2026 James Park Renovations and Pathway Improvements

Bid # 26-15

ADDENDUM No. 3

April 3, 2026

SEWER ROUTING MAP

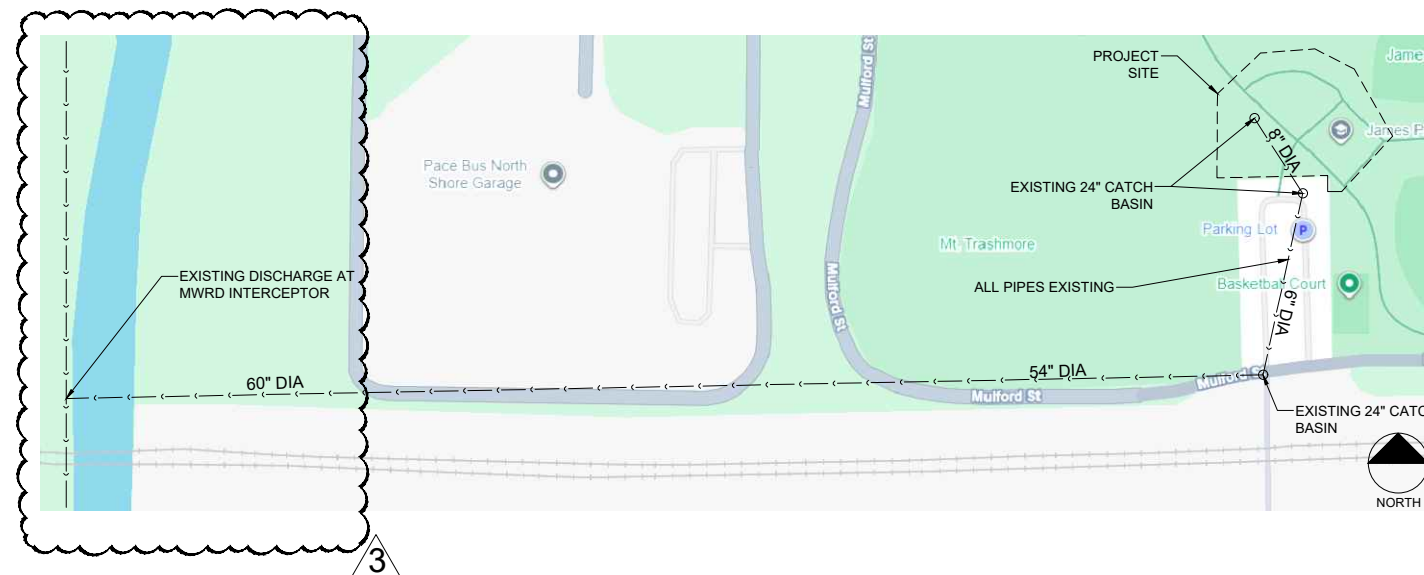
- Index of Drawings update to match specification section 01 00 00
- Existing Sewer Routing Map update to more accurately represent existing conditions.

C-06

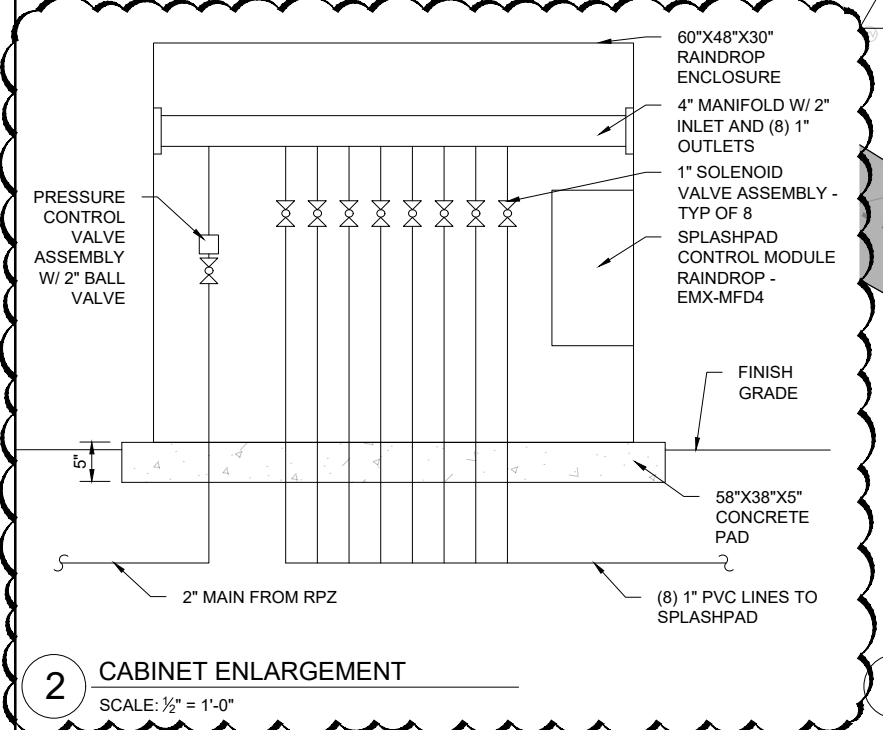
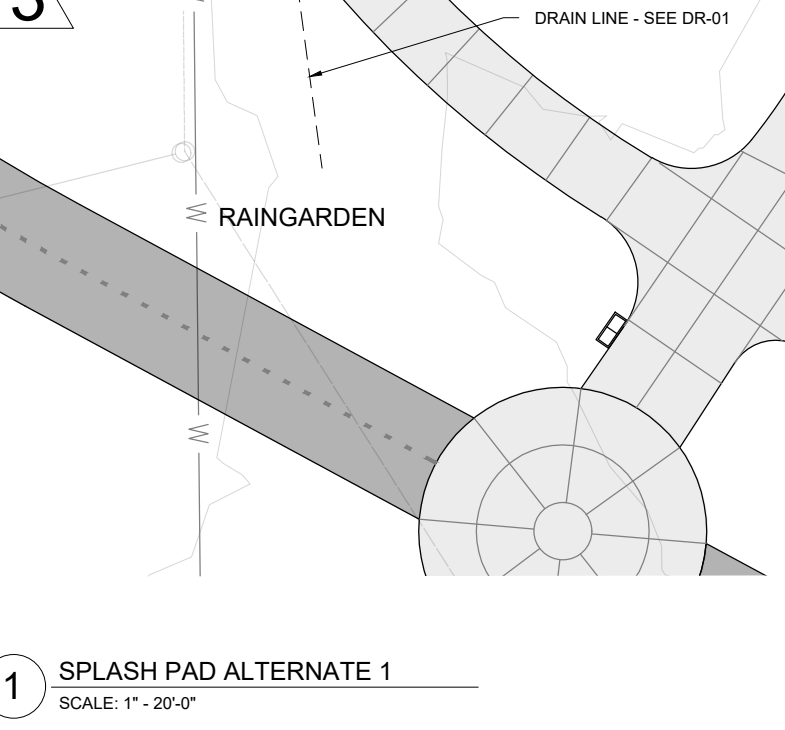
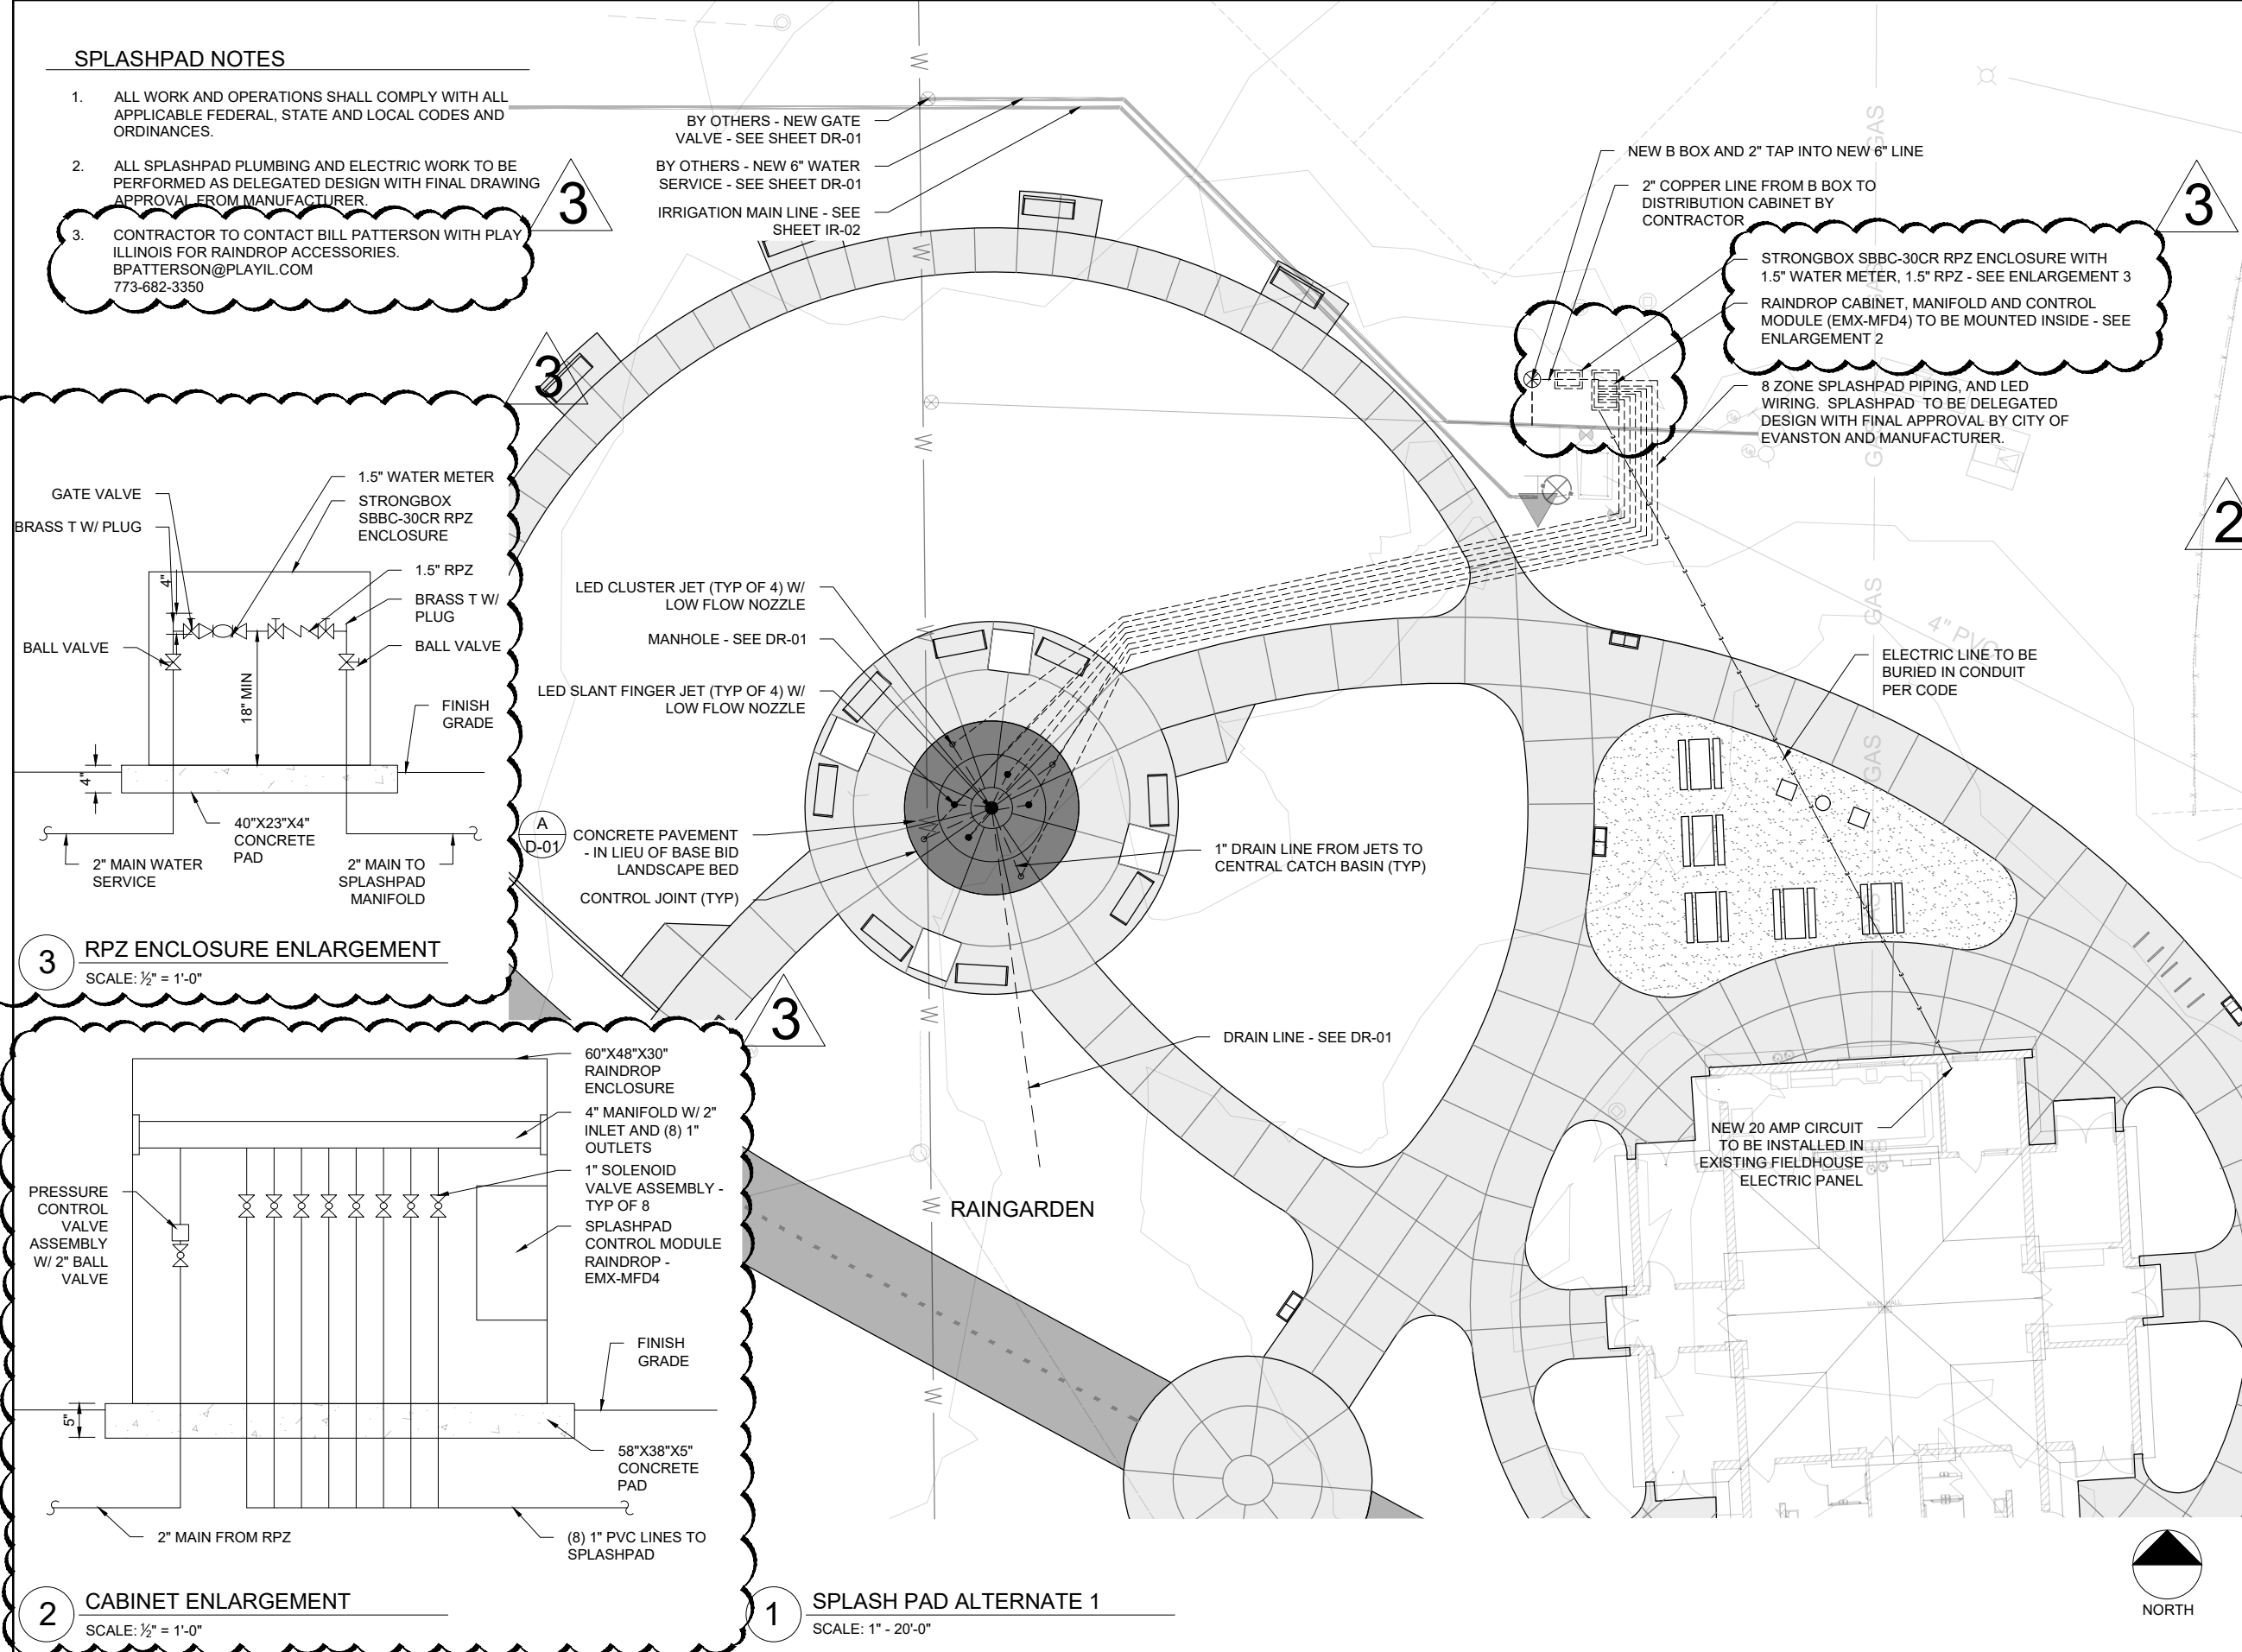
Sheet C-06.0 - attached

- RPZ Enclosure update
- Cabinet enlargement update
- Addition of contact information for supplier

SHEET NO.
C-06.1

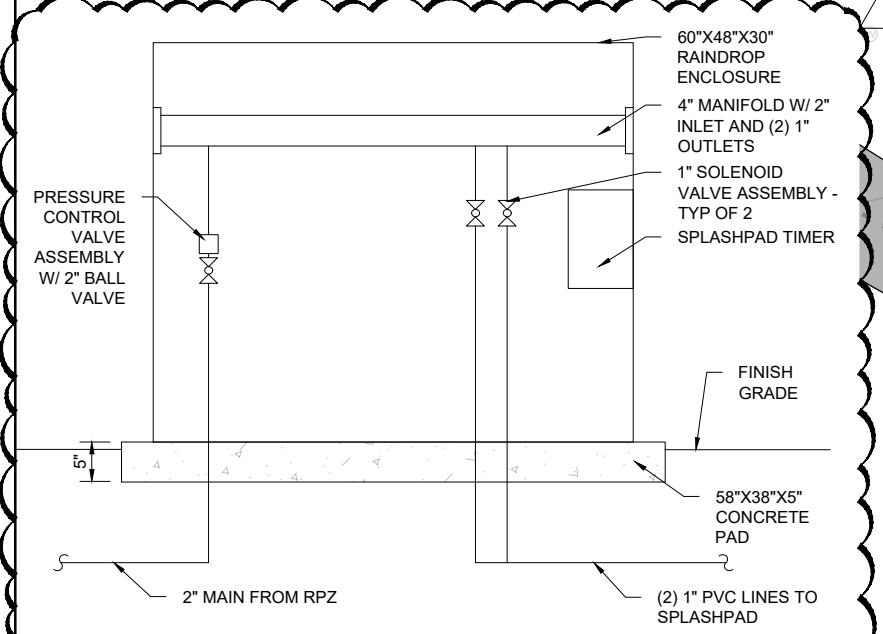
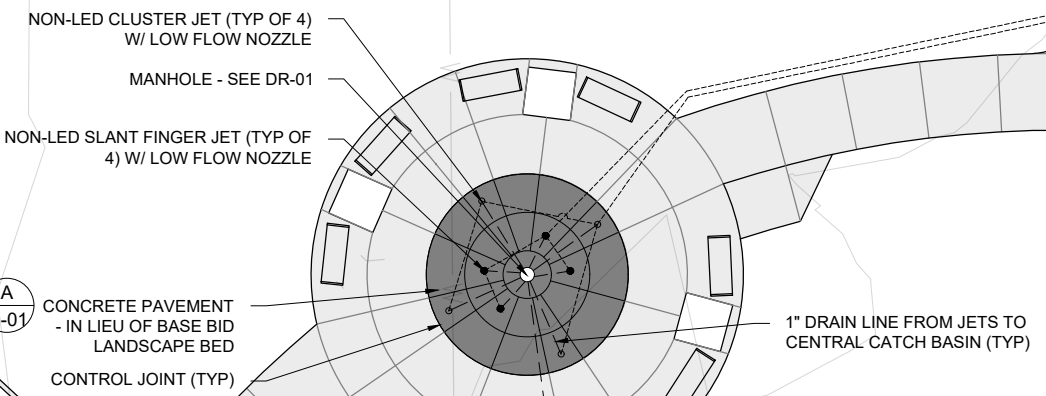
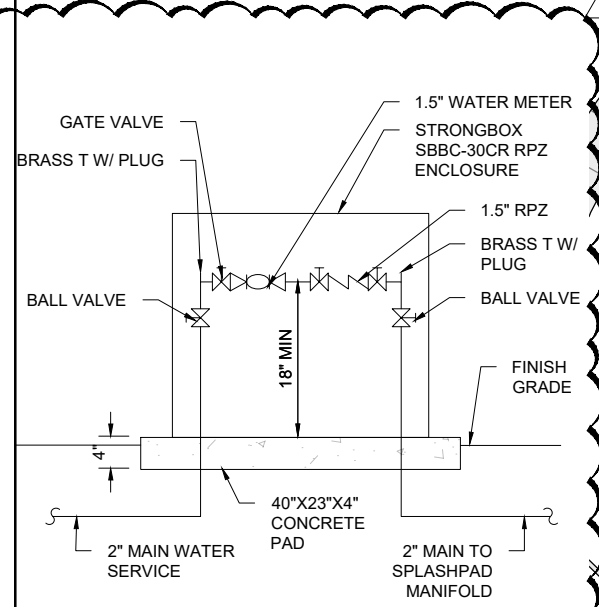
Sheet C-06.1 - attached

- RPZ Enclosure update
- Cabinet enlargement update
- Addition of contact information for supplier
